SEQUENCE 1.20

MANUAL ADDENDUM

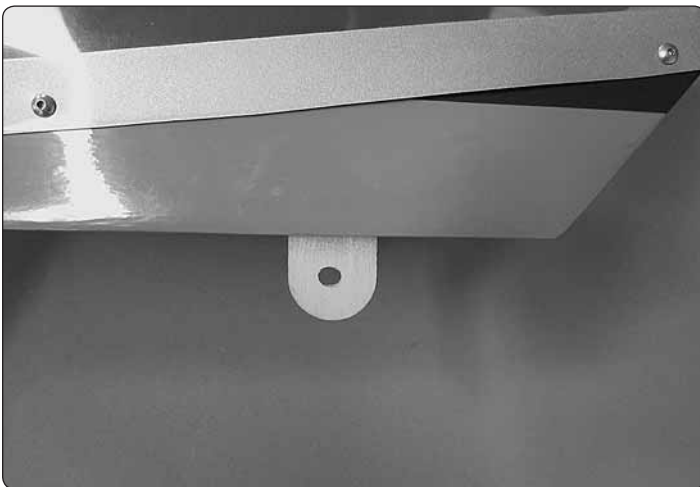
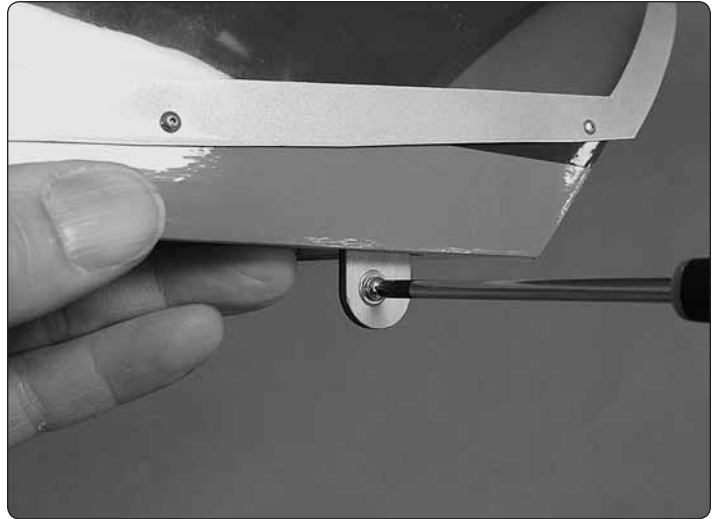
We've encountered a few instances in which the blind nuts in the canopy hatch do not align with the holes in the fuselage making it difficult to install the canopy hatch screws. The quick, easy fix is to relocate the blind nuts as illustrated:

1. Insert a 4-40 bolt a couple turns into the blind nut. Use a soldering iron to heat the blind nut to melt the glue, then you can easily push the blind nut out.
